143909-001-01.DWG
002020

GENERAL PLAN
ELEVATION AND NOTES

500 MG X 76'-6 BCL WATERSPHEROID
LOWELL, MA

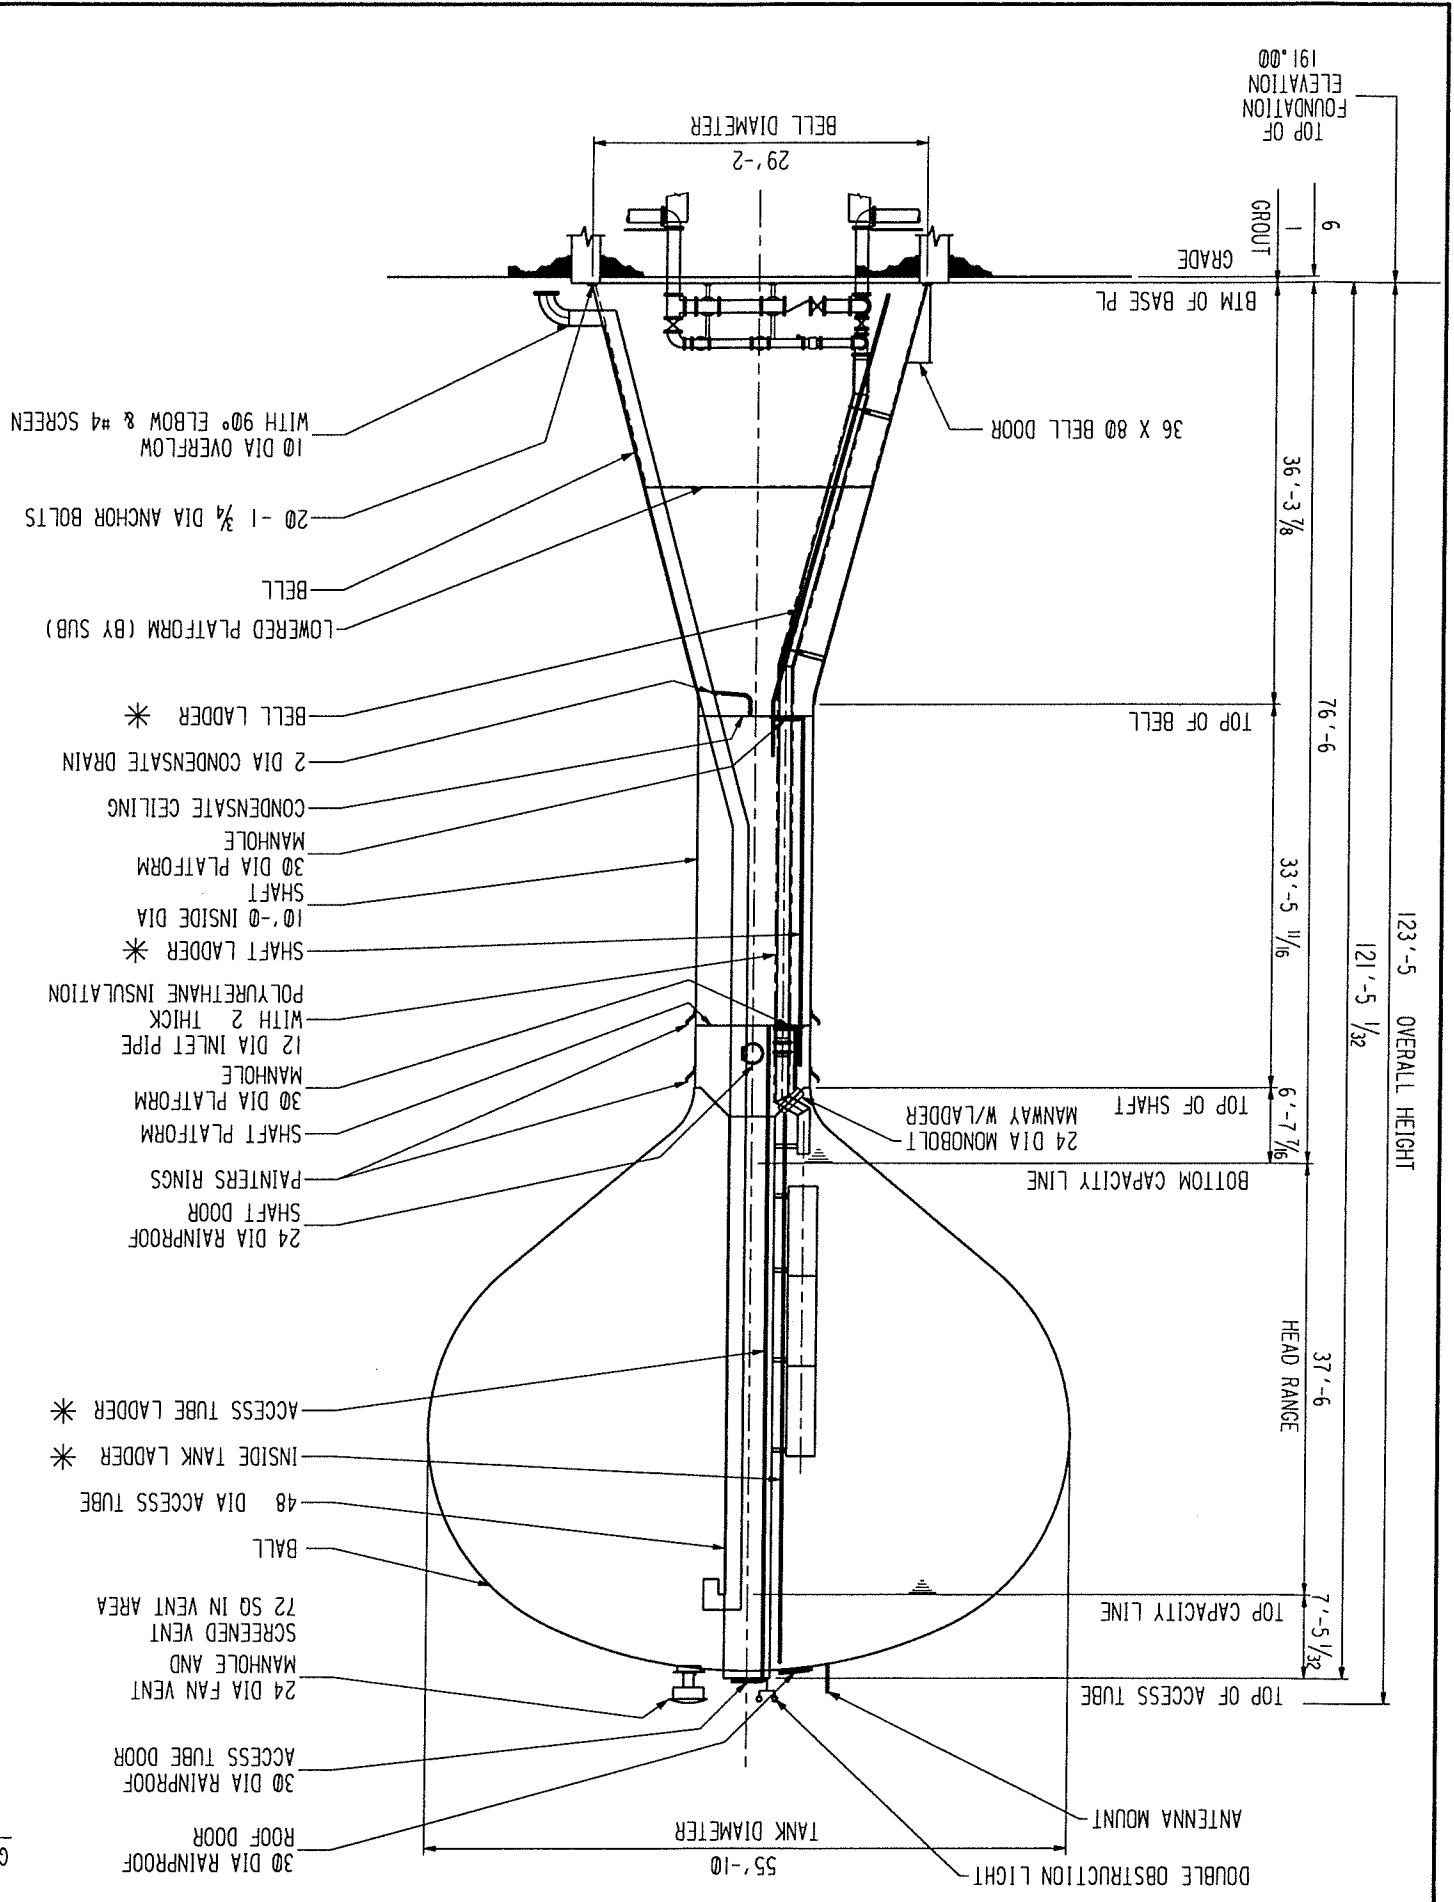
VENT SCREEN CHANGED FROM BRASS TO
STAINLESS STEEL
DATE 7/27/05

1. BEEN ANCHOR BOLTS AFTER TIGHTENING TO PREVENT EASY REMOVAL OF NUTS.
2. DETAILS IN ELEVATION HAVE BEEN ROTATED INTO PLANE OF PROJECTION. SEE SECTIONAL VIEWS AND DWG. 2, SHEET 1 FOR TRUE ORIENTATION.
3. GROUT UNDER BASE PLATE BEFORE FILLING TANK WITH WATER. * 4. LADDERS ARE TO BE EQUIPPED WITH SAF-T-CLIMB RAILS.
* 5. VENT SCREENING TO BE STAINLESS STEEL.
